Wild Planet
RE: FCC ID: N3ESPYTRACKR70044

Transmitter bottom

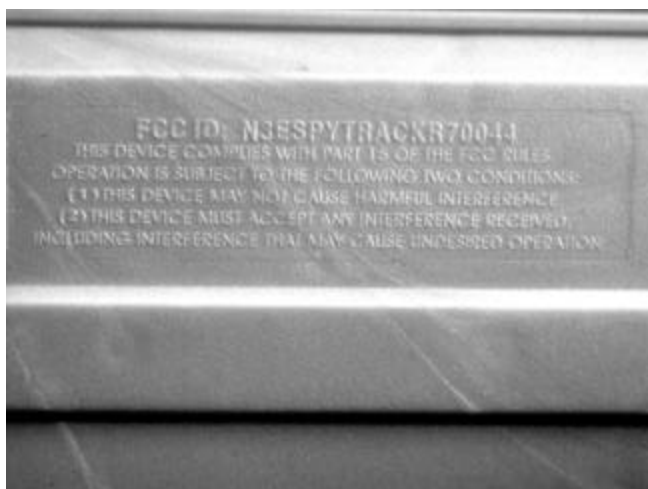
1 Please note that section 15.19(a)(5) can only be used when the device is “so small or for such use that it is not practicable to place the statement specified under paragraph (a) of this section on it”. The device appears large enough to contain the statement of 15.19. There also does not appear to be any ‘practical’ reason why the two condition statement cannot be on the device. Please provide justification for not placing the two condition statement on the device or please provide a corrected label containing this statement.

Response: The Part 15 statement will not be able to fit on the Transmitter bottom portion, since the size of the engraved letter, used for the FCC statement, is too big. I have included a picture from the Receiver, which is large enough in size for the FCC statement to fit, but the statement is too large in size to fit on the transmitter.
